Product Change Notification / GBNG-30ZMTP819

CCB 4284 Initial Notice: Qualification of GTK as a new assembly site for selected SST39VF640xxx and SST39VF320xxx device families available in 48L TSOP (12x20mm) package.

CCB 4284
Pre and Post Change Summary
PCN #: GBNG-30ZMTP819

LPI

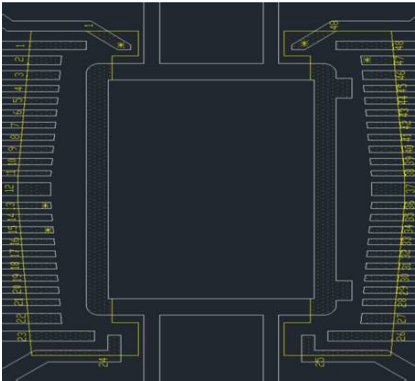
Paddle size	276 x 350 or 190 x 250 mils
Lead Lock	Yes
DAP Surface Prep	Double ring plating

GTK

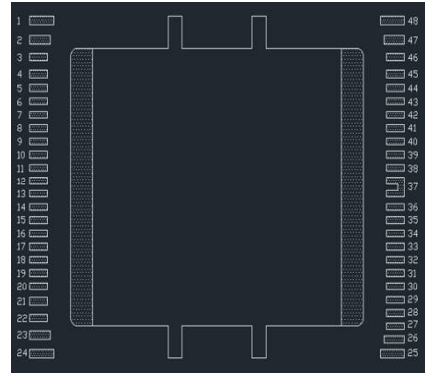
Paddle size	330 x 260 mils
Lead Lock	No
DAP Surface Prep	Ring plating
